INDEX TECHNICAL SERVICE BULLETIN

Alcyon (TM) System Software 1.6 Recall

TSB#: 120-009A

Alcyon® Hardware Upgrade 2

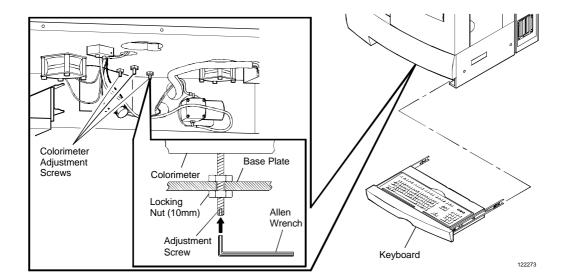
The optical count specification for all wavelengths is 10000 - 23000 counts.

The optics assembly will need to be adjusted if the optical counts are outside the specification. Locate the three adjustment screws as shown in figure below.

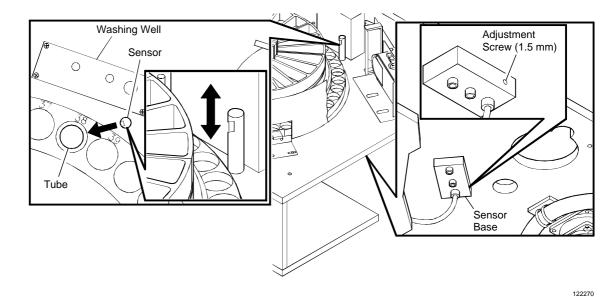
Tube/Cup Detector Alignment Procedure

The tube/cup detector on some instruments may not be properly aligned. A probe crash may result if a tube is detected when a cup is present. The alignment eliminates the chance of this problem from occuring.

6. Adjust the tube/cup detector either up/down or rotationally to optimize the signal to the controller as illustrated below. Tighten the adjustment screw when the alignment is correct.

Alignment of Lower Bracket to Upper Bracket

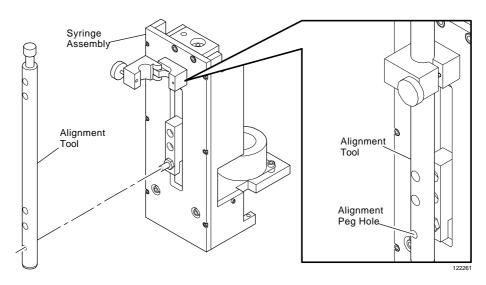
Syringe Drive Upgrade

The syringe drive will be upgraded to improve the alignment of the syringe piston to the glass barrel. This upgrade will improve the life of the syringe pistons.

A tool has been released to align the new lower support to the upper bracket. Before installing the lower support, verify the post is secured to the bracket.

1. Remove the lower bracket on the syringe drive, then install the new lower support. Do not

Installation of New Syringe

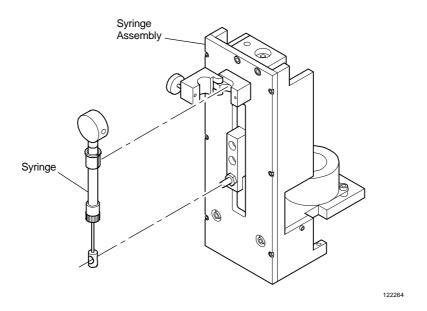
New Syringe Assemblies

The syringe assemblies will now be supllied by Kloehn. These new syringes reduce the manufacturing inconsistencies from the old syringe supplier.

1. Install the new syringes as shown below. Verify the circle "T" is secured to the each syringe.

Figure 12.

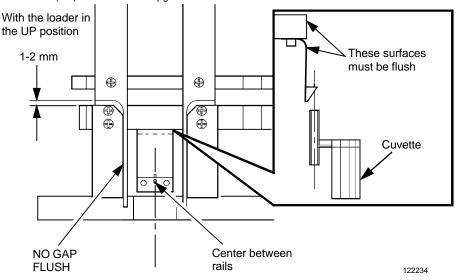
1. Verify all dimensions are met as shown in Figure 12.
